Re: Cresson Project Permit M-1980-244, "Cripple Creek & Victor Gold Mining Company Squaw Gulch VLF Phase I (9450'-9550' Bench) Project Final Report Quality Assurance Monitoring & Test Results."

**RE: Cripple Creek & Victor Mining, Co. Cresson Project M-1980-244;  
Review Comments for Quality Assurance Monitoring & Test Results Final Report for Squaw Gulch  
VLF Phase 1 (9,450 to 9,550 Bench)**

CRIPPLE CREEK & VICTOR GOLD MINING COMPANY  
SQUAW GULCH VALLEY LEACH FACILITY - PHASE 1  
**CONCRETE REMEDIATION OF  
UNDERGROUND WORKING #6320  
PLAN VIEW**

*Photo 1 Completed Geomembrane Fusion Weld*

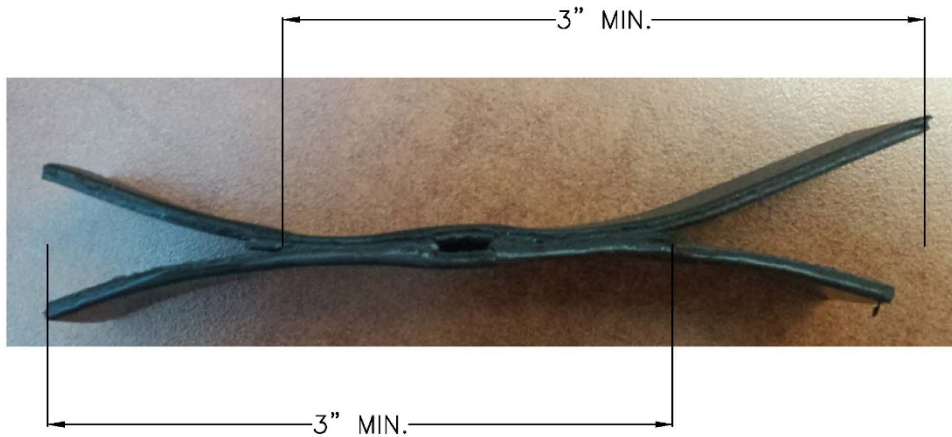
2. *Sect 6.3.2, Seaming Observations: The response is partially adequate The Division accepts installation recommendations from Agru for a minimum overlap of 75 mm (3"), but we are confused as to how 3 inches on the top layer and 3 inches on the bottom layer add up to 6 inches. The standard overlap diagrams shown below (Figure 2 for a hot wedge seam and Figure 4 for an extrusion weld seam) would suggest an eight-inch overlap (Figure 2) and a 12-inch overlap (Figure 4) if we understand the statement in the response. Please confirm that is what is meant or provide a sketch explaining how two three-inch overlaps results in a six-inch overlap*

The 6-inch overlap called out in Appendix J is how we document in the field showing the minimum overlap during deployment has been met in order to complete a successful weld. Adding 3 inches from the top (edge of weld to tail) and 3 inches on the bottom (edge of weld to tail) together, it is noted as 6 inches. The installer sometimes exceeds this minimum overlap during geomembrane deployment, which is acceptable as the excess length is cut off the tail after fusion welding is complete. Photo 1 demonstrates the above description. This allows for destructive testing of the weld.

ISSUED DATE  
**09/28/2015**  
PROJECT No.  
**74201125N0**  
FIGURE No.  
**UG27**  
REV  
**1**

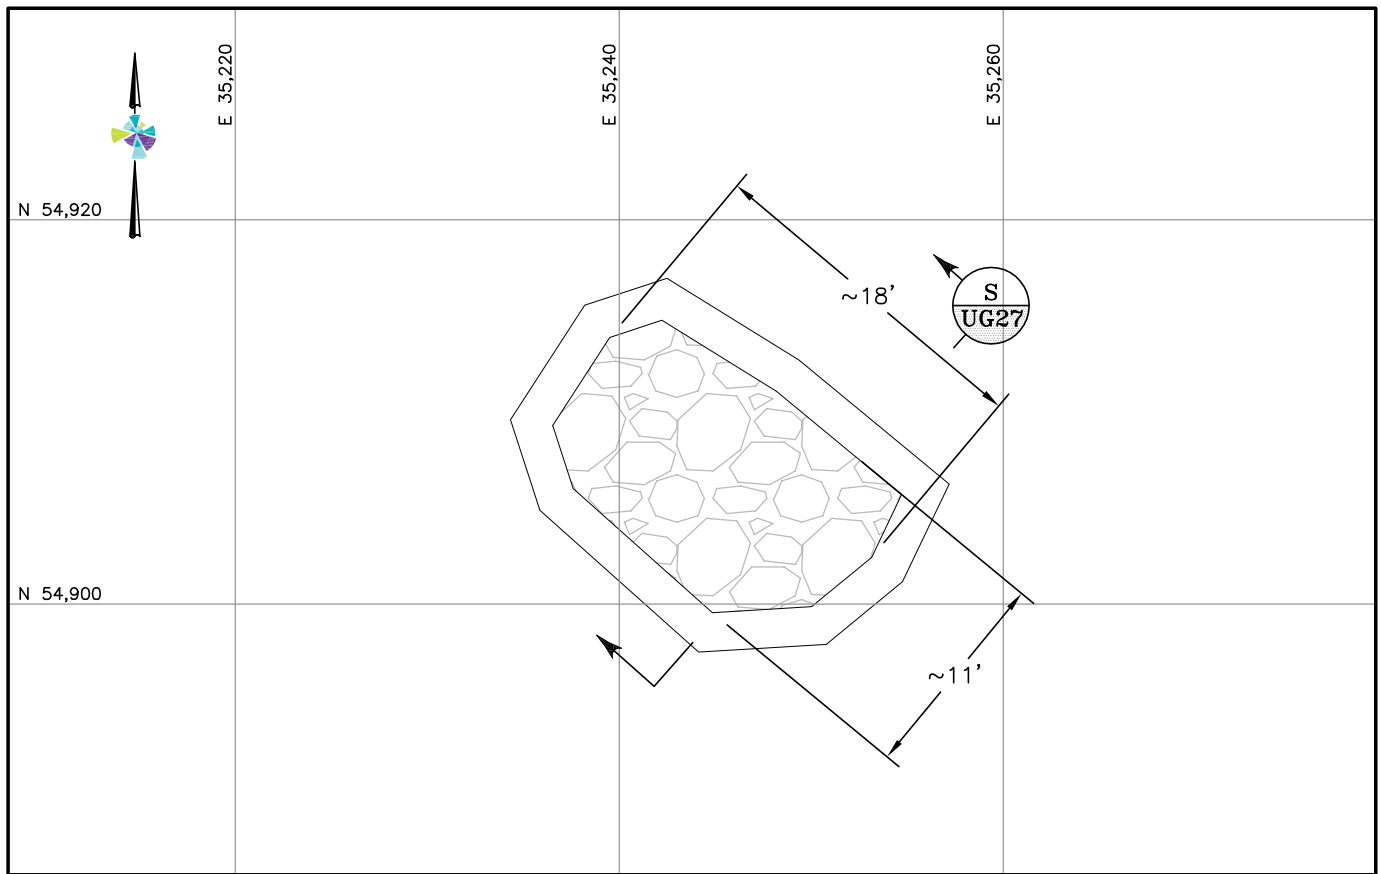
- i. *Note 3 on Figure UG27 states “25 CY of approved 4020 mix concrete and 45 CY of 300 psi mix concrete was placed as a substitution for cemented rockfill.” The response is unacceptable. Again, the Division cannot overemphasize the need for the Certifying Engineer to be familiar with the approved designs and specifications. Having excess material that does not meet the required specification is NOT justification for using the excess material. It must be demonstrated to the Division’s satisfaction that the admittedly lower compressive strength flowable fill material used in the remediation of Underground Working #6320 will have no adverse impact on the function and/or integrity of the VLF liner system over the design life of the VLF in the vicinity of UG #6320. Furthermore, it is not acceptable to change the unspecified “4020 Mix Concrete” to “Approved 4001 mix without any explanation. If it cannot be demonstrated to the Division’s satisfaction that the future integrity of the VLF liner has not been or will not be adversely impacted by this substitution of substandard material, the Division will require UG #6320 to be re-excavated and remediation performed to meet the approved Drawings and Specifications.*

Figure UG27 specific to Underground Working #6320 has been attached with this response letter to demonstrate the remediation and add clarification to the explanation presented below of the remediation of Underground Working #6320.

The bottom of the concrete plug elevation is established 15 feet below the subgrade elevation (12 inches below the design SLF surface). A 3-foot thickness of 4,000 psi concrete was placed to construct the plug. The thickness of the concrete was measured at the time of the pour using a grade stake marked at three feet. A 3-foot-thick plug is the minimum thickness required. Placement of additional 4,000 psi concrete is allowable. To achieve the required 7-foot-minimum thickness of cemented rockfill over the concrete plug, a 3.5-foot-thick layer of 4,000 psi concrete was placed. The additional concrete was “classified” as cemented rockfill. The compressive strength properties of the concrete far exceed those of the specified cemented rockfill. The required 7-foot thickness of cemented rockfill was completed by placement of a 3.5-foot-thick layer of flowable fill material. The flowable fill was also “classified” as cemented rockfill. The compressive strength properties of the flowable fill also exceed those of the cemented rockfill. The project specifications do not require a minimum compressive strength for cemented rockfill, but require a compressive strength of 300 psi for flowable fill. The remediation of Underground Working #6320 was completed with the

placement of 5-foot-thick layer of structural fill material over the top of the flowable fill to achieve a total 15-foot-thick section below subgrade.

Neither the additional 4,000 psi concrete nor flowable fill material used as a substitution for cemented rockfill is substandard; they both exceed the project specifications. Per the project specifications, flowable fill material is required to have a minimum compressive strength of 300 psi. There is not requirement for compressive strength for cemented rockfill. During remediation of another underground working, a sample of cemented rockfill was cast and compressive strength testing was performed at 3 and 7 days. While a 28 day break was not performed, it is a general “rule of thumb” that a 7 day break is 60 to 75 percent of 28 day strength. The 7 day break for cemented rockfill had a compressive strength of 70 psi, correlating to a 28 day break range of 91 to 119 psi. As such, cemented rockfill has a lower compressive strength than flowable fill. Per a telephone conversation with the Division, we have included a photograph showing the appearance of cemented rockfill. Please note this picture is not from working UG#6320 and is for visual reference only.

The concrete mix as outlined on the Appendix M.3 Underground Workings Concrete summary table and the individual test report #17 located in Appendix M.4 call out “4001 Mix Design”; “4020” on Figure UG27 included in the October 2015 ROC report was incorrect. It is speculated that while the

figure was being drawn, the technician began with "40" for the mix design and ended the second half of the number of the UG working number "20". The figure was revised to show the correct mix design as those documented in Appendix M.3 and Appendix M.4.

1. SLOPE = 0.5H:1V MINIMUM.
2. STRUCTURAL FILL USED IN REMEDIATION EFFORT.
3. 25 CY OF APPROVED 4001 MIX CONCRETE WAS PLACED FOLLOWED BY 38 CY OF 300 PSI FLOWABLE FILL PLACED AS SUBSTITUTION FOR CEMENTED ROCK FILL.
